CITY OF ST. PETERSBURG, FLORIDA

STAFF REPORT

Community Planning and Preservation Commission Certificate of Appropriateness Request

Case No.: 22-90200013

Figure 2: Approved front elevation with new side addition. The plans state that the roofing material will be shingles to match existing house.

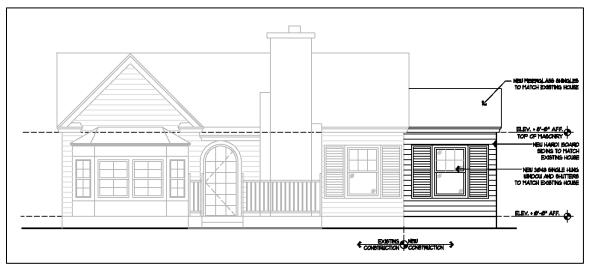
The COA application (Appendix A) proposes an after-the-fact change from the approved roofing material on the side addition from asphalt shingles, to match the main house, to metal roofing. The metal roof has already been installed, and the change of roofing materials was identified during an in-progress inspection. According to the COA Matrix, a change in roofing material requires approval by the Community Planning and Preservation Commission.

The proposed metal roof is highly publicly visible from elsewhere in the district and from 28th St. N. and would alter the subject property's appearance by introducing a glossy material with vertical texture while the main roof historically had and currently has roughly textured, small-scale shingles.

Inconsistent The addition should have a similar design, texture, materials, and visual quality as the roofing material on the historic resource. Metal roofing is not consistent.

Based on a determination of general consistency with Chapter 16, City Code of Ordinances, staff recommends that the Community Planning and Preservation Commission **DENY** the after-the-fact Certificate of Appropriateness request for the alteration of the property at 2750 Dartmouth Ave. N.

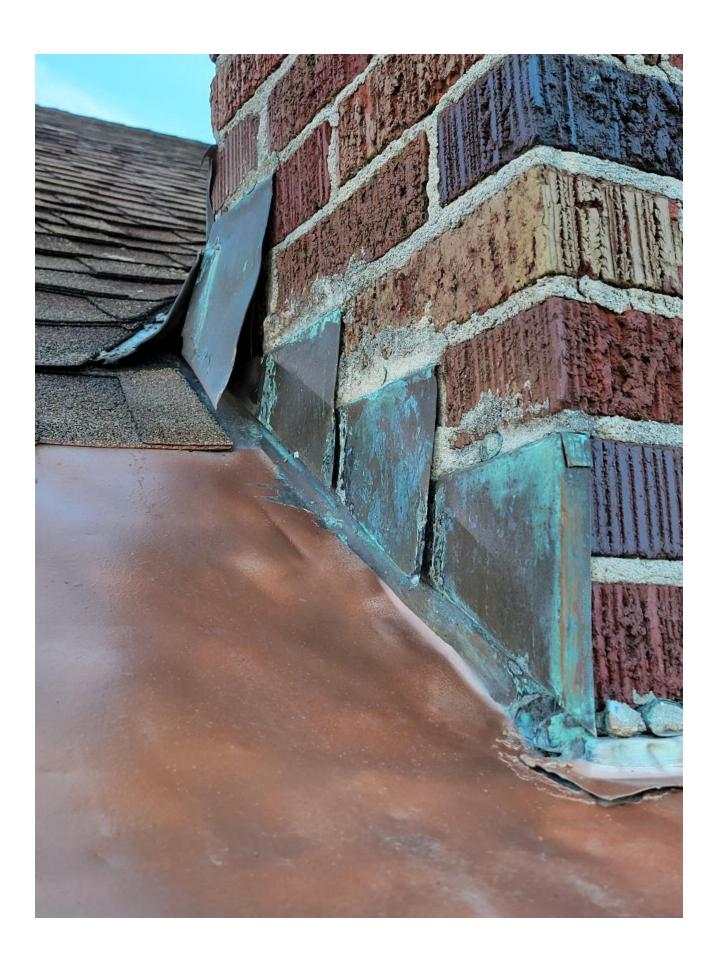
The owner has noted several reasons why the change in material should be approved. The application cites the front door overhang with copper. Staff is of the opinion that this front door overhang is not original to the house, as it appears to be applied over the existing roof edge, indicating it was added after construction. The overhang also covers original roof features, which also indicates it was added later.

- 1: Original to home construction: copper overhang on house: like metal materials
- 1: Front view overhang

2. Garage roof: City of Saint Petersburg permitted and approved

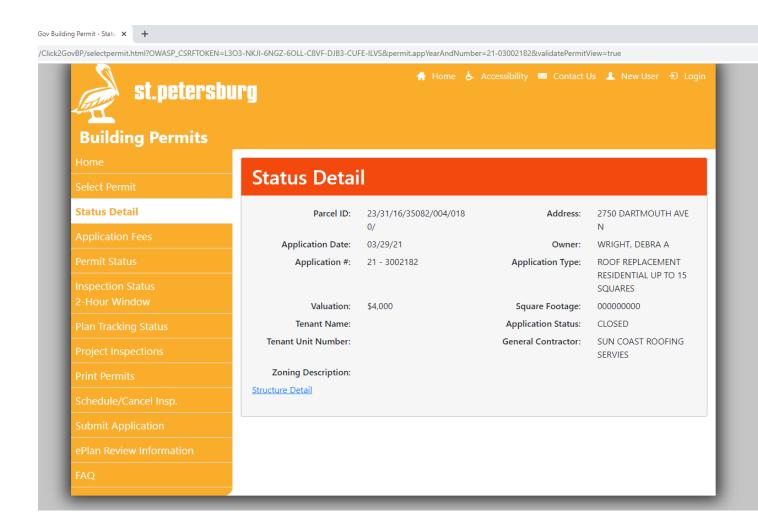
The application also mentions the reroofing of the subject property's garage and the reroofing of 2660 Dartmouth Ave N. Both of these permits for reroofing were pulled as online service permits. Within the online application procedure for a residential roof permit, an applicant is required to agree that the roof will be replaced with like roofing materials. There are also approval notes provided at the time of permit issuance stating that there is no change to materials, as a change requires Zoning approval. A residential roof replacement in Neighborhood Traditional (NT) including a change in materials is required to receive Zoning approval to ensure it complies with City Code Section 16.20.010.11. No Zoning review was performed for these permits.

3: Permitted and approved metal roof, 2660 Dartmouth (5 houses east of my home)

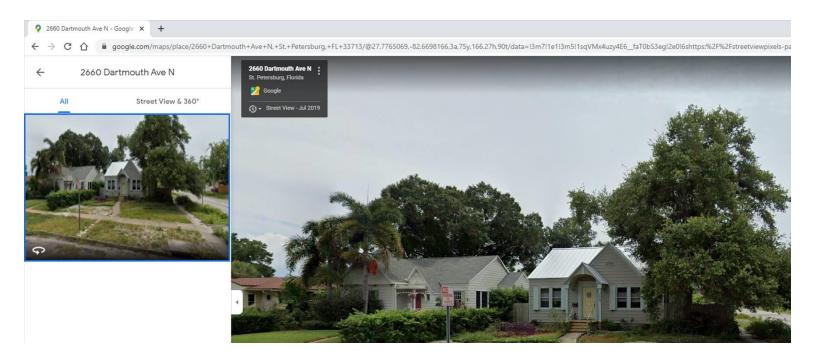
This project is dissimilar, in that building permits for the project stated the material was to be asphalt shingles to match the main house. This project received a COA with the condition that any additional work shall be presented to staff for a determination of additional COA approval. The change in materials was not presented to staff prior to installation, as required. Had it been presented prior to installation, staff would have counseled the property owner against the requested change using the same justifications for denial described within this report.
